Remote Link and System Link
January 2009

Version 1.45 Software Update

Effective January 2009, all Remote Link and System Link are being shipped as Version 1.45 (12/30/08) software. This version is an update from the Version 1.44 (8/5/08) software previously shipped and contains new features.

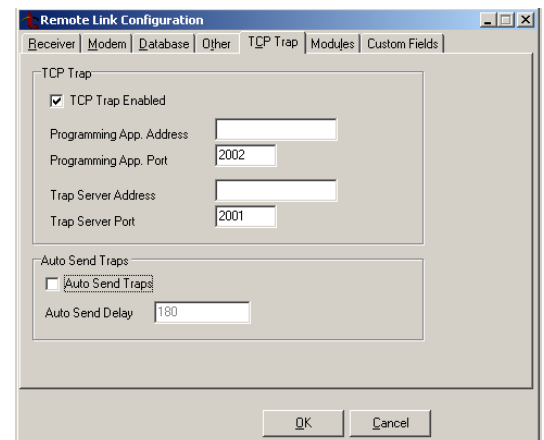
Remote Link now supports Auto Send Traps to prevent the receiver from discarding a trap after four hours.

Auto Send Traps: This enables Remote Link to resend all trap commands periodically to the SCS-1R receiver. This refreshes the receiver and prevents discarding of the trap after a four-hour period of no contact from the panel. The interval to resend all trap commands is based on the number of seconds programmed into the Auto Send Delay option. Default is unchecked.

Auto Send Delay: If Auto Send Traps is enabled, enter the number of seconds that Remote Link waits between resending traps. Default is 180 seconds. Minimum is 30 seconds.

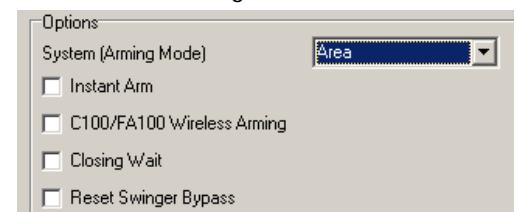
A new option has been added to Zone Information to allow the zone being programmed to follow any exit or entry delay running in a specified area.

Follow Area (XR500 Series/XR100 Series Version 203 or higher): Allows Night, Day, Aux 1, or Aux 2 burglary zones to be delayed by following any exit or entry delay that is currently running in the area that is specified.
